## ADDENDUM #2

### RSU #57 – DESIGN-BUILD MODULAR CLASSROOM BUILDING PROJECT

86 West Road, Waterboro, Maine

23 February 2024

CAREHAWK INTERCOM SYSTEM WIRING DIAGRAM

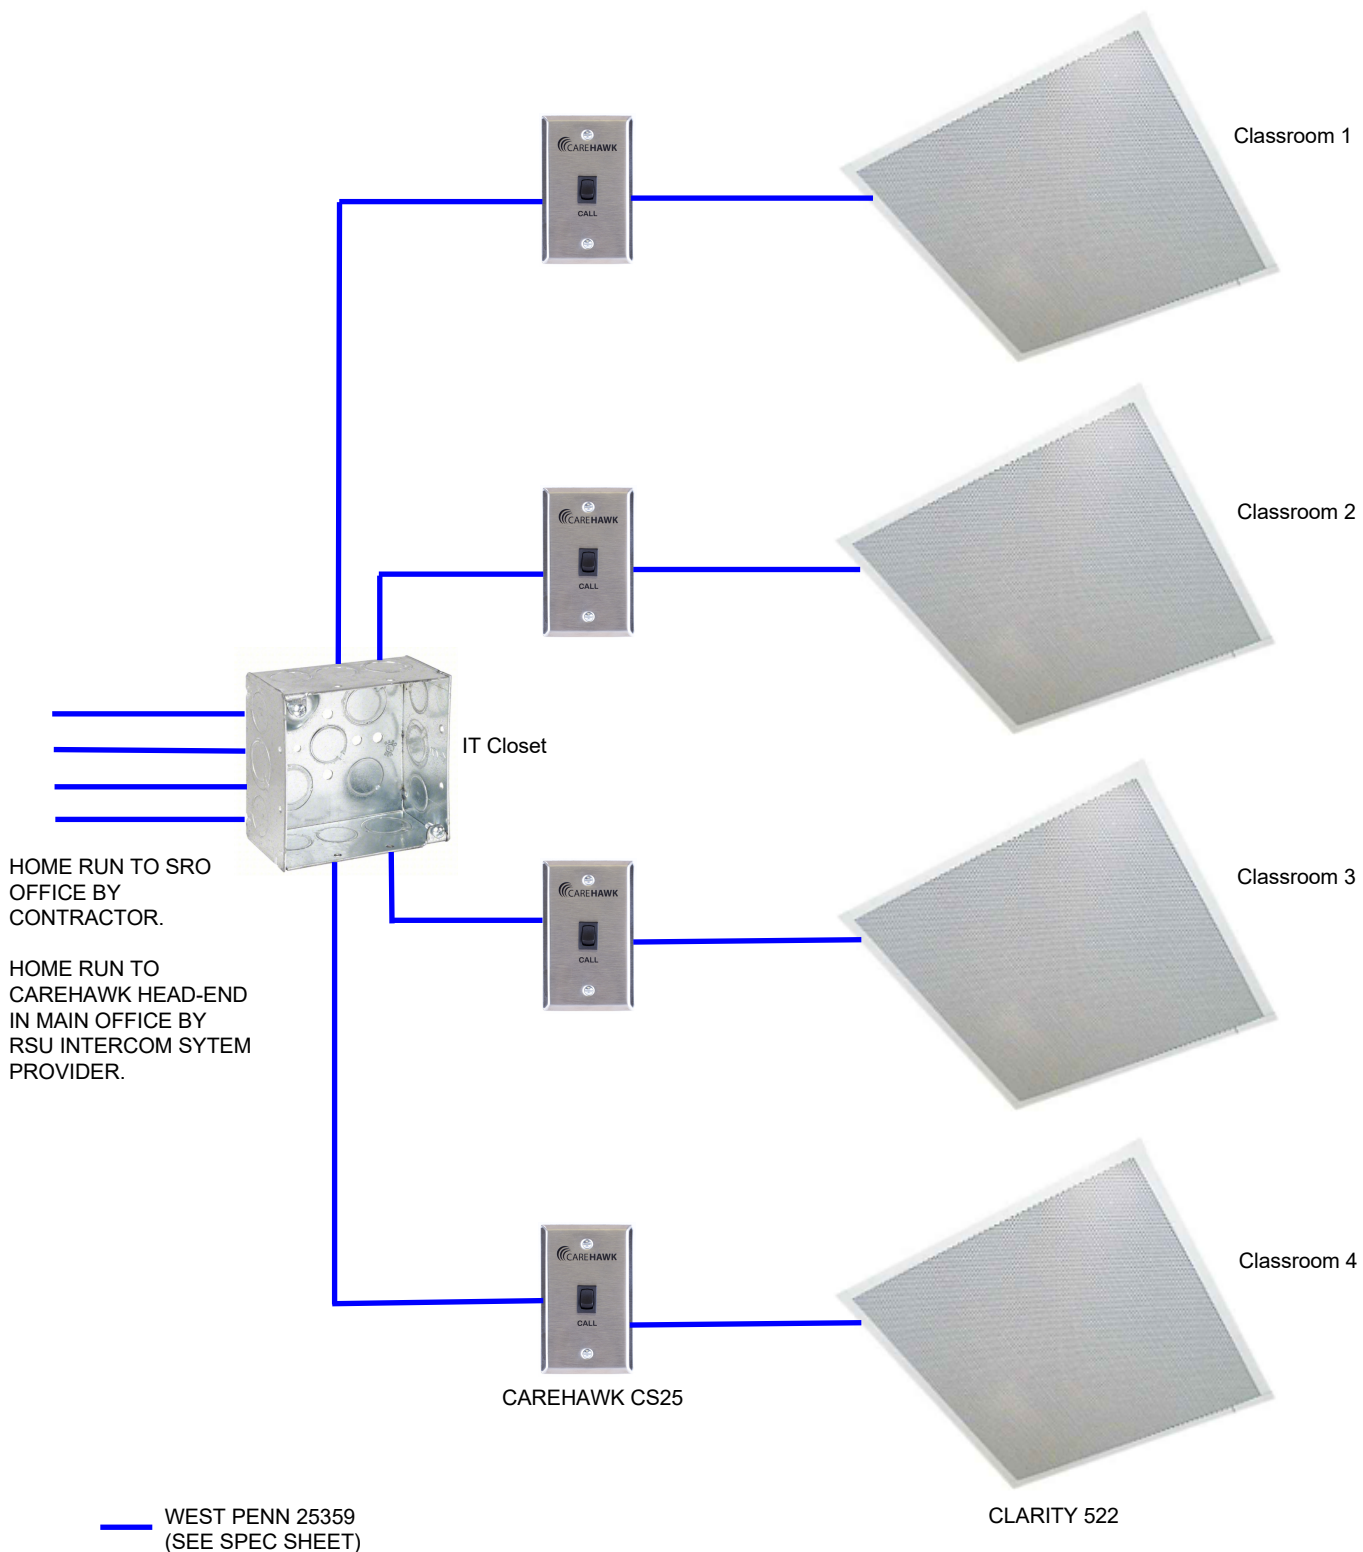
5. Will the new building require PA linked to the existing school?

**Response:** Yes, the new modular building shall have an intercom (PA) system. The system will consist of one 2x2 lay-in ceiling speaker in each classroom and a call station inside each classroom

door, quad junction box in the IT Closet with 4 individual wires pulled within the new fiber optic data conduit that will be run to the school resource officer's (SRO) office adjacent to door 7 with the 4 wires left coiled above the ceiling of the office for completion by others. The new conduit for the fiber should be properly sized for the additional 4 West Penn 25359B wires. Each classroom call station shall have a single gang junction box with West Penn 25359B wire run in conduit to above the ceiling and left coiled for connection to the speaker and a conduit and West Penn 25359B wire run to the IT Closet quad junction box and left coiled for connection to the homerun to the SRO office. Refer to the attached system diagram and product cut sheets. Questions should be directed to the RSU's intercom system provider: Scott Whitaker, Canfield Systems, Inc., 89 Mussey Road, Scarborough, Maine; Office: 207-883—4110; Mobile: 207-650-0938; [scott@canfielssystem.com](mailto:scott@canfielssystem.com)

DRAWN: MPV	DATE: JANUARY 2024
DESIGNED: ADJ	SCALE: 1" = 40'
CHECKED: ADJ	JOB NO. 17-003
FILE NAME:	
SHEET: C-101A

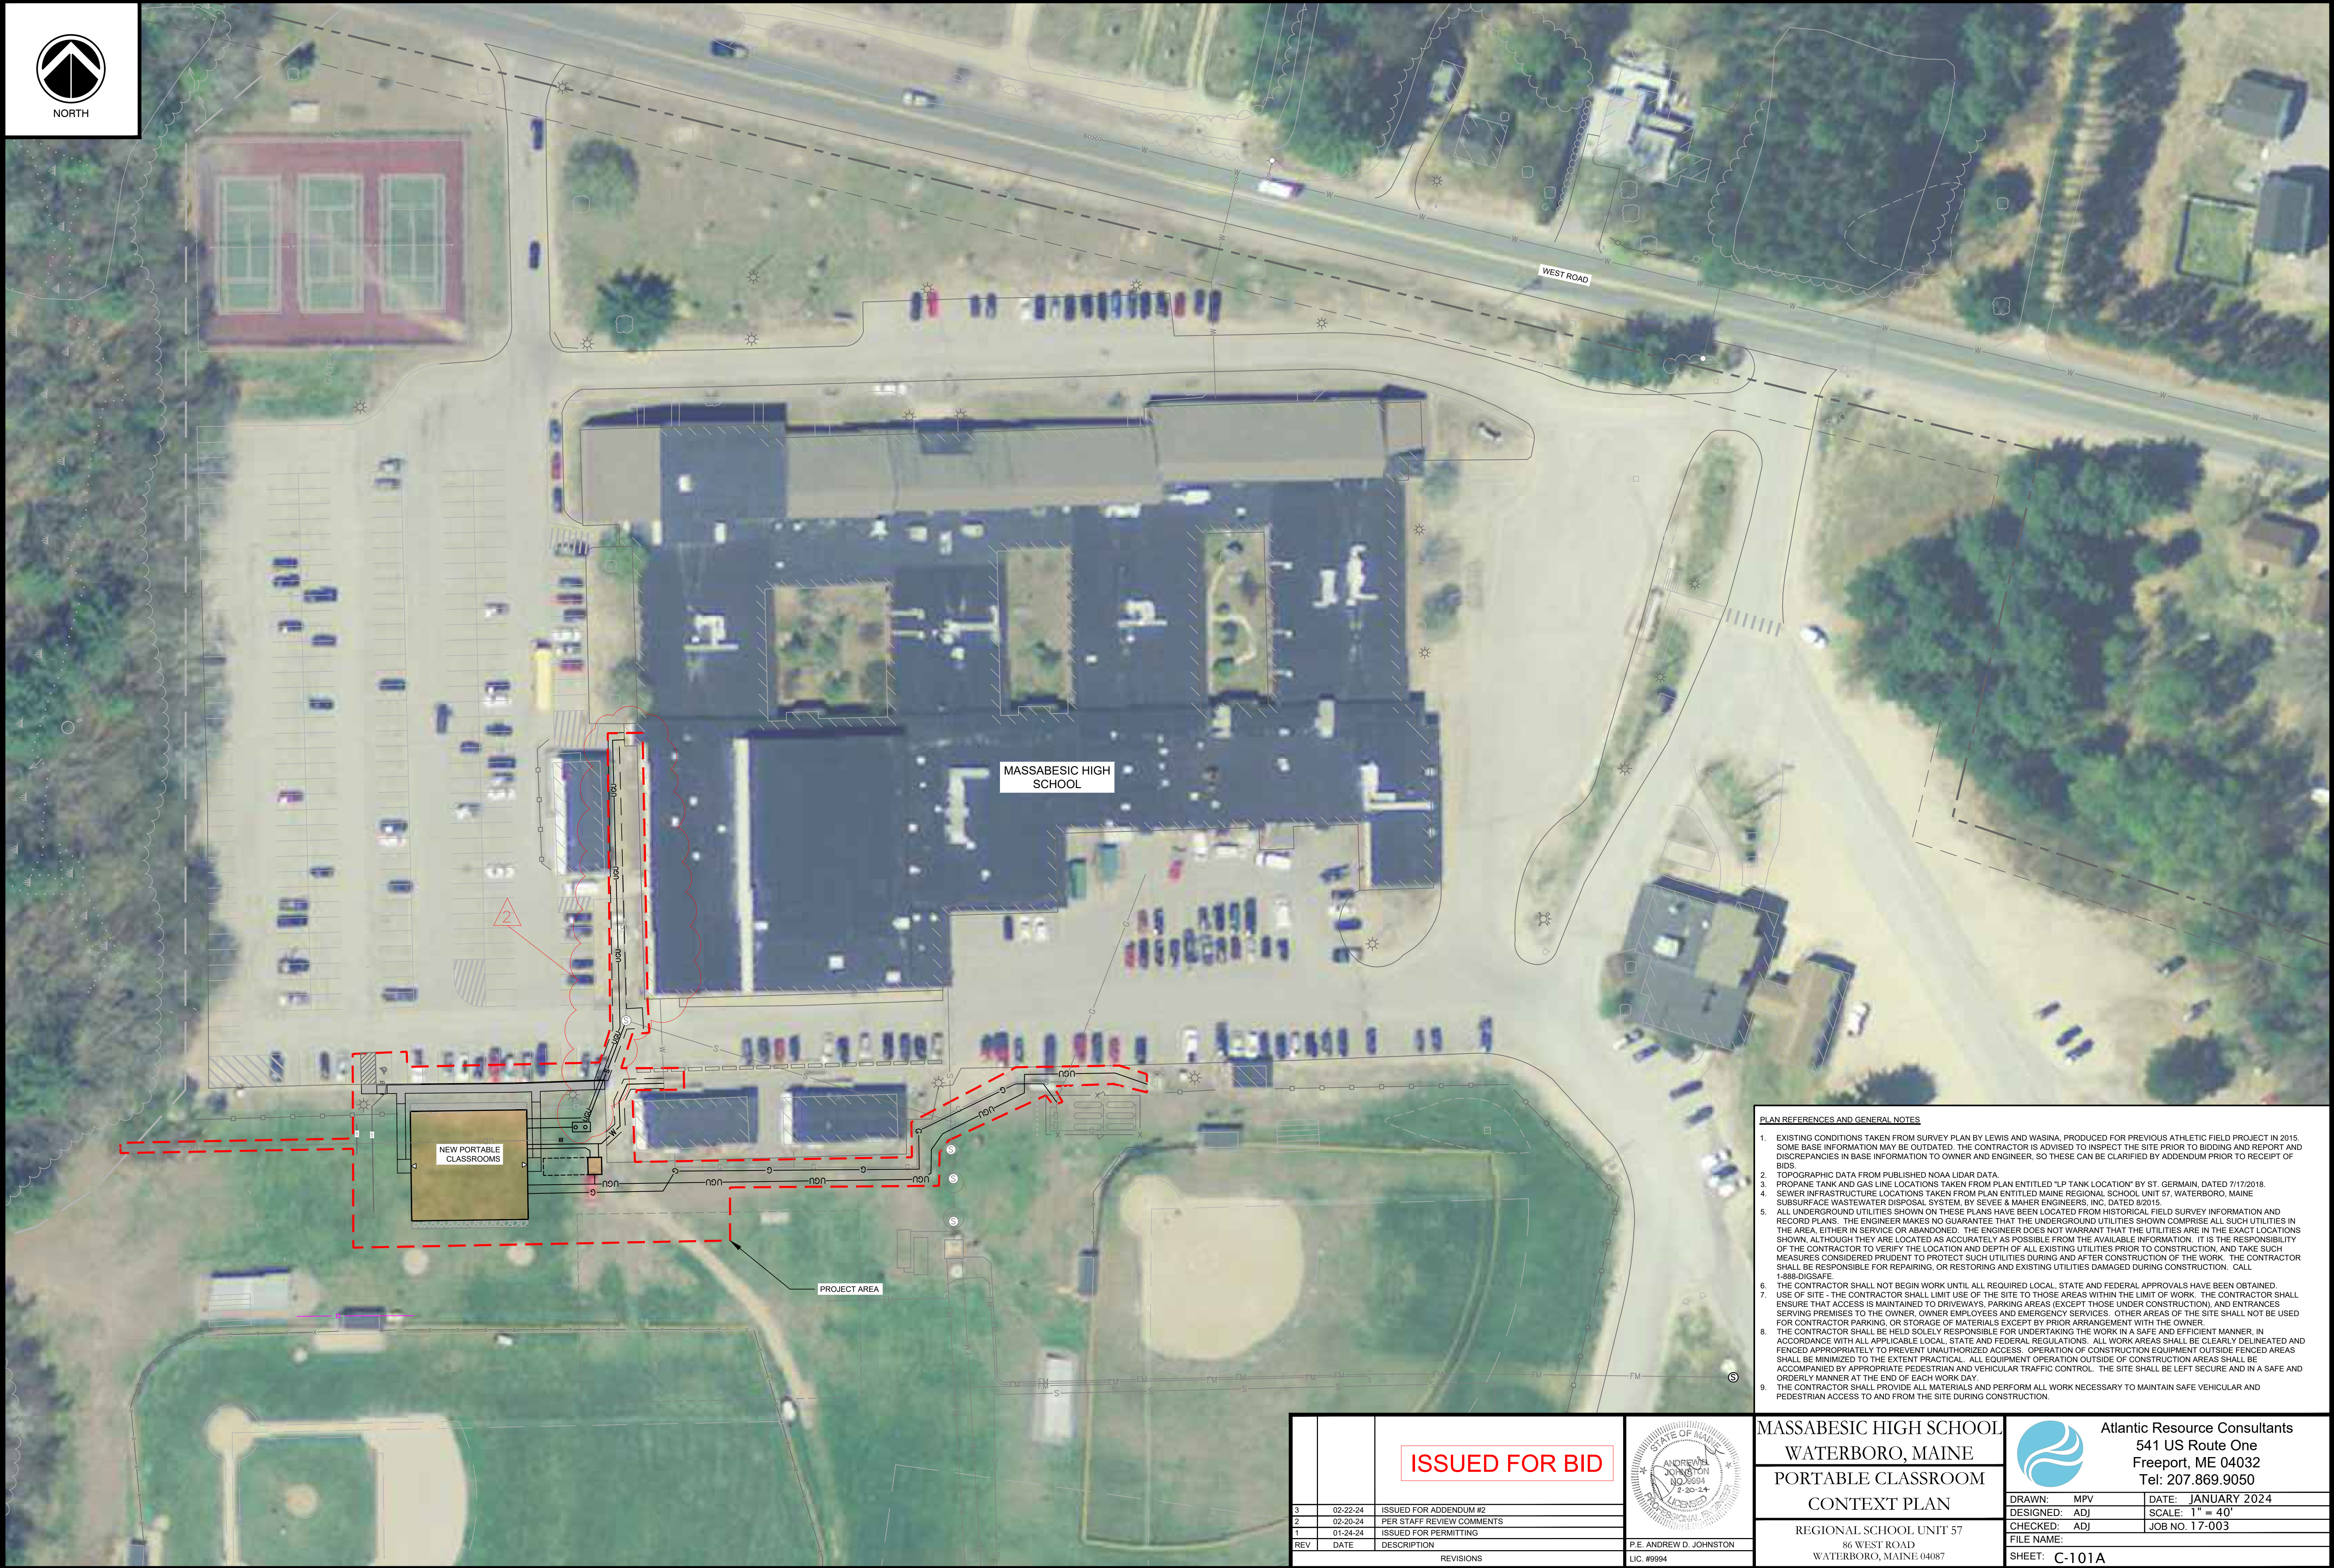
1. Delete drawing C-101A, Portable Classroom Context Plan; and insert the attached revised drawing C-101A, Portable Classroom Context Plan; changes include a revision to the Project Area limit of work.
2. Delete drawing C-101B, Portable Classroom Site Plan; and insert the attached revised drawing C-101B, Portable Classroom Site Plan; changes include revisions to show an underground communications pathway and the new sewer manhole is changed to a septic tank.
3. Delete drawing C-301, Portable Classroom Site Civil Details; and insert the attached revised drawing C-301, Portable Classroom Site Civil Details; changes include the addition of a precast septic tank detail.
